Response to Reviewer 1:

First of all, we would like to thank dr. Vincent Verjans for his time for thoroughly reviewing this study. We appreciate the constructive feedback we received. By following your suggestions, we have, amongst other things, revised the sensitivity analysis, model evaluation, and various parts of the text. We believe these changes have led to an improvement in the quality of the results and manuscript.

Fig. Examples of the MO fit empirical relations for the relative FAC and surface elevation change uncertainty.

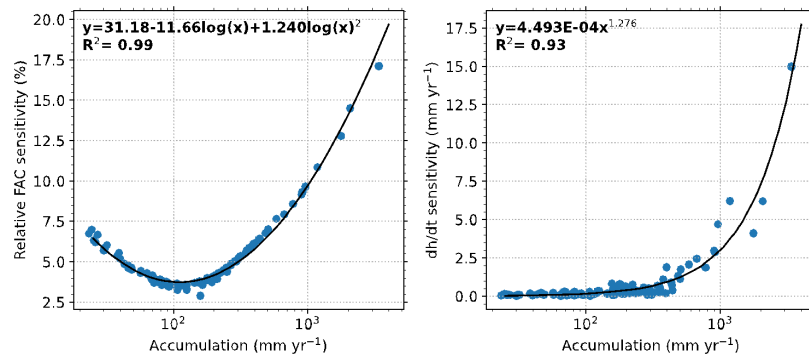
The authors have investigated the results of the sensitivity experiments only at the firm core locations. However, this is of little interest to the community. A method to compute uncertainty estimates over the entire ice sheet in the different components of Eq. (6), and thus ultimately on dh/dt, should be developed. A straightforward approach could be to sample perturbations in all uncertainty sources mentioned in Section 2.6, compute

simulations at key locations, and regress uncertainty estimates against climatic variables. However, I leave the choice to the authors of how to best estimate uncertainty from their model, and I note that they have already worked on similar issues (e.g., Kuipers Munneke et al., 2015). The outcome of a more thorough uncertainty analysis should be:

- uncertainty bands in time series of Figure 7 and Figure 9
- maps of total uncertainty in modeled surface elevation change (and possibly of the uncertainty components)
- a quantification and discussion of the different components to uncertainty in dh/dt across Antarctica

Thank you for this recommendation. We agree that ice-sheet wide uncertainty estimates are of greater interest to the community. We expanded the uncertainties estimates by regressing the sensitivity of the uncertainty sources mentioned in Section 2.6 against climatic variables for the average FAC and dh/dt . We propose to include details of the sensitivity analysis in the supplementary material. As there are many interacting processes in the model, which can be variable in time, we propose to regress dh/dt instead of the different components of Eq. (6) separately. In addition, we propose to estimate the ice-sheet wide average FAC sensitivities as well in a similar manner. The empirical relations for each sensitivity experiment are included in the Figures S3. An example of these empirical relations is given in the Figure below.

These empirical relations are used to expand the sensitivity of the sample locations to the entire ice sheet. We have added the resulting maps of the total FAC and surface elevation change uncertainty and the contribution of each uncertainty source in Figures S4.

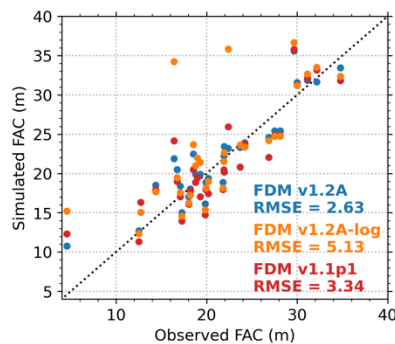
This modest introduction of independent data in the evaluation results in (line 243): “a slightly deteriorated correlation for the MO550.” when compared to the FDMv1.1p1 parameterization.

I think there is a misunderstanding here. The deteriorated correlation of the MO₅₅₀ fit is not because of the introduction of the independent surface snow density data, as the independent surface snow density data has no impact on the MOfit. The r-squared value of the FDM v1.1p1 MO₅₅₀ fit is higher (0.43) than the FDM v1.2A MO₅₅₀ fit (0.37). The reason for this could be that the previous fresh snow density parameterization was based on accumulation, which can give a higher dependency of accumulation and MO₅₅₀. We propose to rephrase Lines 242-244 as: “The optimal MO₅₅₀ fit is less steep than the one found by Ligtenberg et al. (2011). The fresh snow density is now independent of accumulation and generally lower, and hence more densification is needed at high accumulation sites to match the density profiles. This might explain the slightly deteriorated correlation of the MO₅₅₀ fit.”

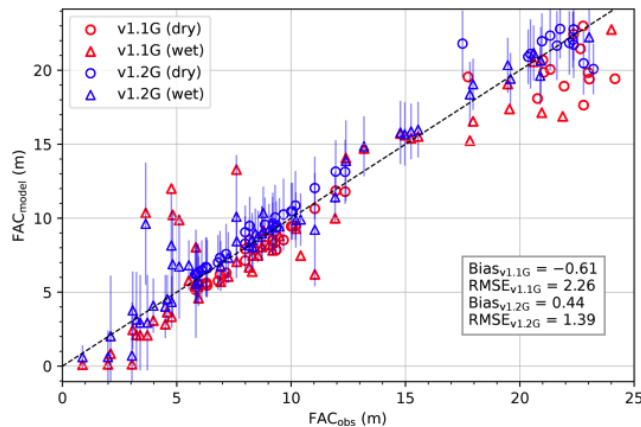
The MO parameterization is constrained only in dry firn areas, but the model is used in wet firn areas also. One can reasonably expect errors to be much larger in modeling wet firn densification. While this topic is not the focus of the study, any ice-sheet wide study of firn evolution should at least discuss this limitation. Ideally, I would encourage the authors to evaluate IMAU-FDM in the wet firn areas also, by comparing modeled FAC to observed FAC from firn cores. They could also provide uncertainty estimates that are valid for melt areas.

Thank you for pointing this out. It can indeed be expected that densification rates are different between dry and wet firn. Unfortunately, firn cores from melt areas are sparse in Antarctica, and we only found two that were of sufficient quality to calculate FAC. Especially in melt regions, forcing uncertainties have a large impact on the simulated FAC. In Greenland more cores with FAC observations are available, see Brils et al. (2022), their Fig. 5 (see below). Based on that result, the model appears quite capable of simulation wet firn densification.
